To: Honorable Mayor Patrick Collins and Members of the City Council  
From: Connor White, Planner II  
Subject: PUDC-26-126 / A&H Park at Sweetgrass – Expedited Plat  
Date: July 13, 2026

**CITY OF CHEYENNE PLANNING COMMISSION**  
**JULY 6, 2026**  
**STAFF REPORT**

**FILE:** PUDC-26-126: A+H Park at Sweetgrass (Expedited Review)

**A & H PARK**  
**At Sweetgrass**  
CHEYENNE WYOMING

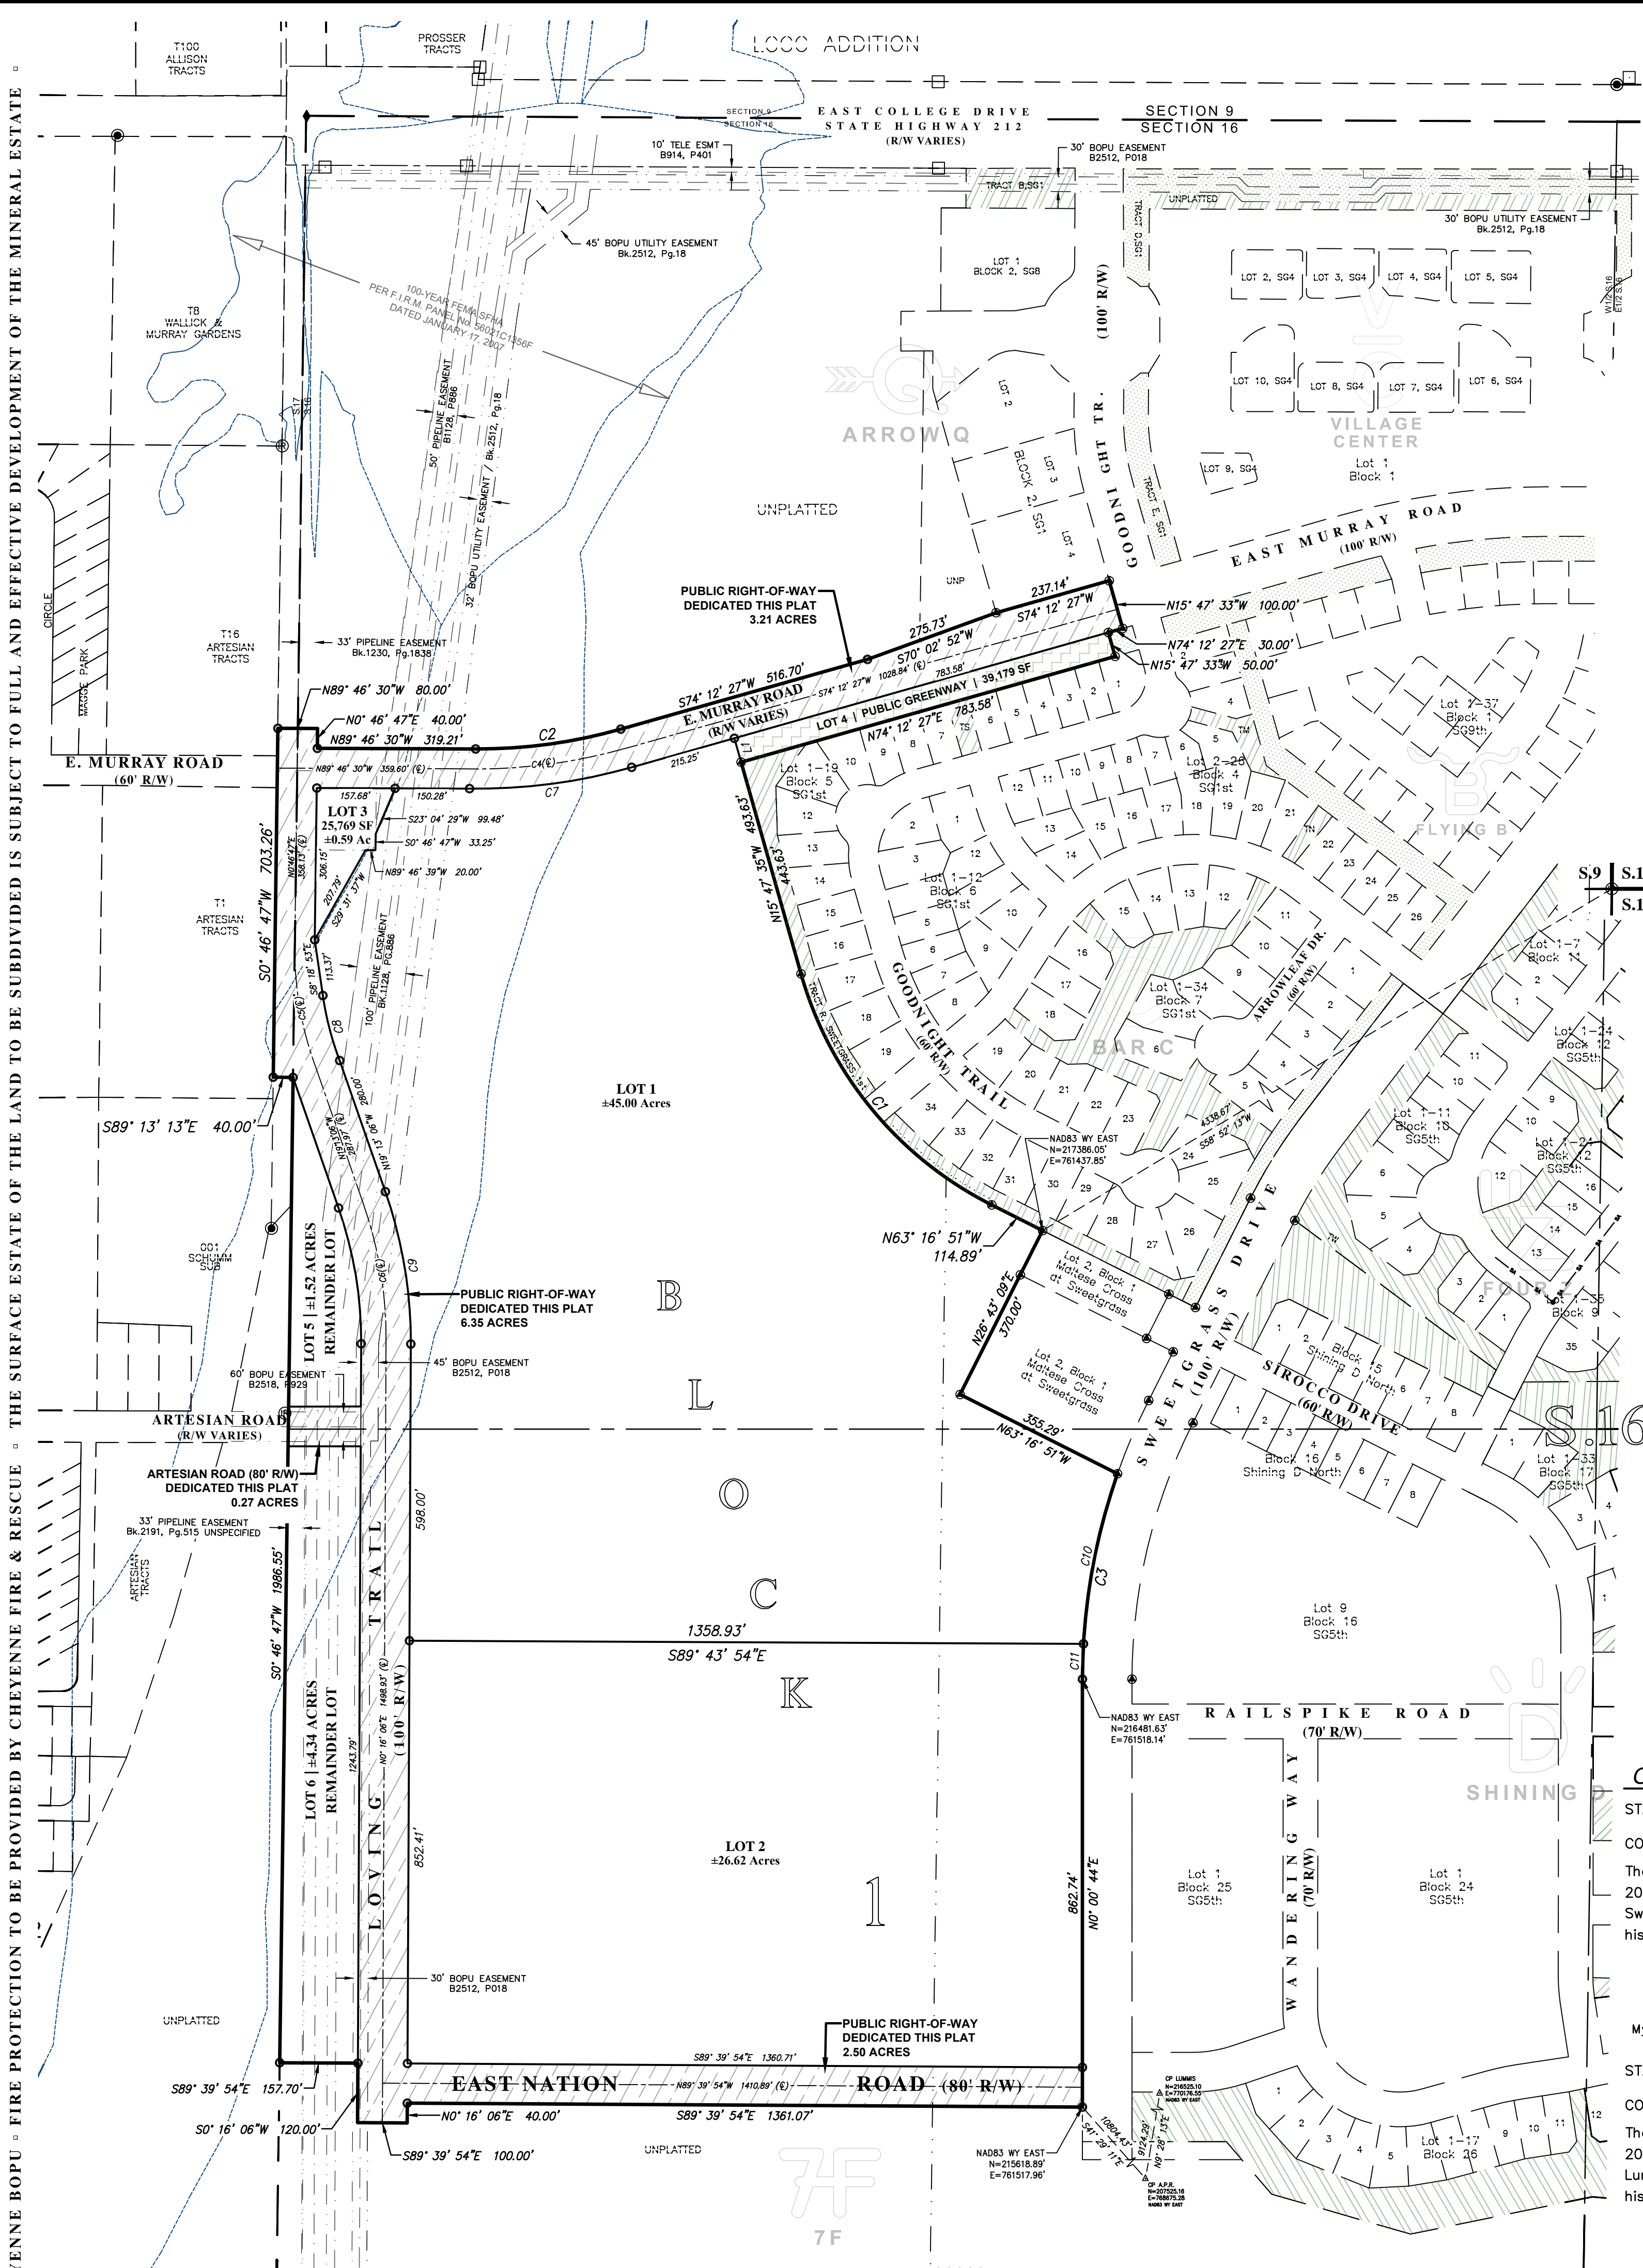
This plat proposes the missing connection of E. Murray Rd. to create an East-West connection into and out of the Sweetgrass Development. Loving Trail (formerly known as Avenue C) is proposed to extend further south to East Nation Rd. East Nation Rd. will provide a secondary East-West connection for the Sweetgrass Subdivision. A plan for construction of the rights-of-way being platted with this subdivision has not been provided. The expectation is that this

plat will build all streets dedicated with it (UDC 4.1.5.b.6 and 7). Prior to recording of the plat the applicant will need to provide a plan for the installation of all necessary public and private improvements and assurance by bond or certified check or a development agreement or other written legal obligations be approved by the City. Should the applicant choose to do a development agreement, they will be required to draft it and it will be reviewed by the City.

The blocks around the perimeter of the proposed subdivision do not meet block size requirements. This subdivision is creating open space and civic use lots which qualify for an exemption under UDC 4.3.3.c. Staff recommends an exception to block size.

Through staffs review there are technical corrections that need to be made prior to the plat being recorded and the applicant will need to provide a plan for construction of all necessary public and private improvements or draft a development agreement.

1. The following exceptions be granted:
  - a. Exceptions to block size for perimeter blocks due to open space and civic uses.
2. Prior to recording of the final plat:
  - a. A plan for instillation of all necessary public and private improvements be in place and assurance by bond or certified check or a development agreement or other written legal obligations be approved by the City. The development agreement shall be drafted by the applicant and reviewed and agreed upon by the Planning and Development Director and the City Engineer.
  - b. Technical corrections be made.

1. The following exceptions be granted:
  - a. Exceptions to block size for perimeter blocks due to open space and civic uses.
2. Prior to recording of the final plat:
  - a. A plan for instillation of all necessary public and private improvements be in place and assurance by bond or certified check or a development agreement or other written legal obligations be approved by the City. The development agreement shall be drafted by the applicant and reviewed and agreed upon by the Planning and Development Director and the City Engineer.
  - b. Technical corrections be made.
